**ADDENDUM NUMBER 1**

**INVITATION TO BID# 17-311-G**

**HOG WALLOW TRAIL PROJECT  
November 29, 2017**

BASE BID  
HARD SURFACE TRAIL

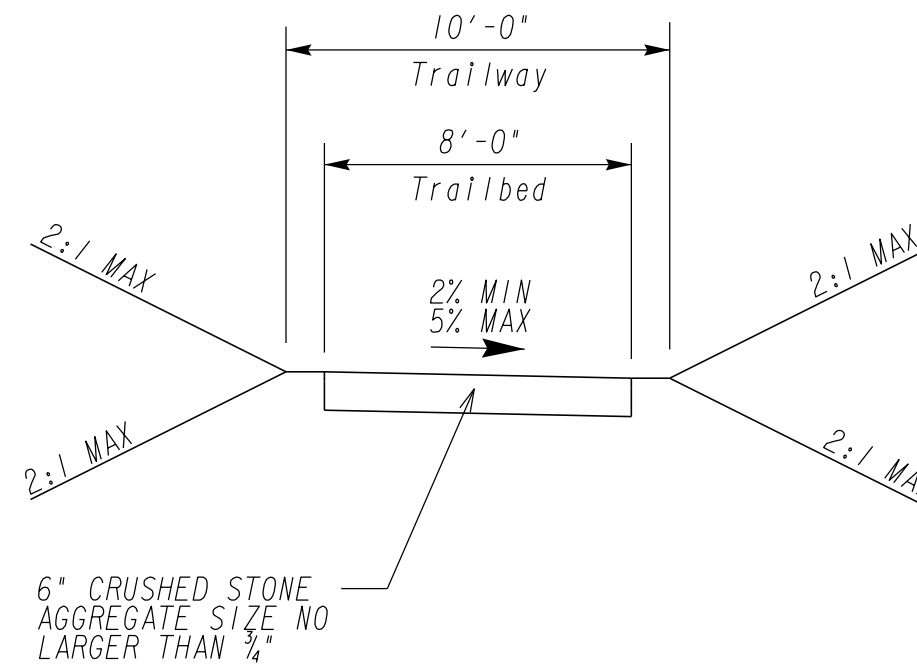
Replace the current Plans page entitled "Cross Section" with Typical Sections with Attachment A to this Addendum - Typical Sections.

6.	Your detail shows 8' path with 1' shoulders- yesterday you mentioned the base material is to be 10' wide- drawing contradicts that statement- please clarify.	Trailway is 10' wide – Trailbed is 8' wide, leaving two shoulders of approximately 1 ft. each. Drawing matches.

ALTERNATE # 1  
SOFT SURFACE TRAIL

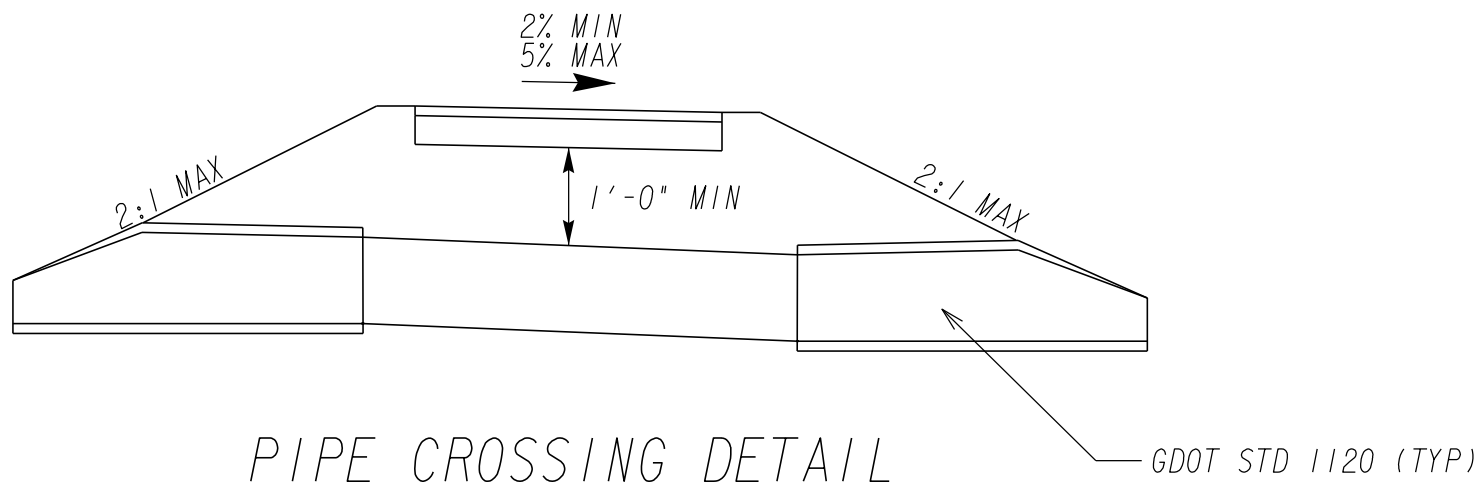
14.	How will the erosion control be handled? How much does the LDP cost, and what requirements are there?	See Answers to Questions 7 and 8.
15.	For Alternate 1, what type of stone should be used?	The trail for Alternate 1 shall be constructed of 6-in crushed stone with an aggregate size not to exceed ¾-in.
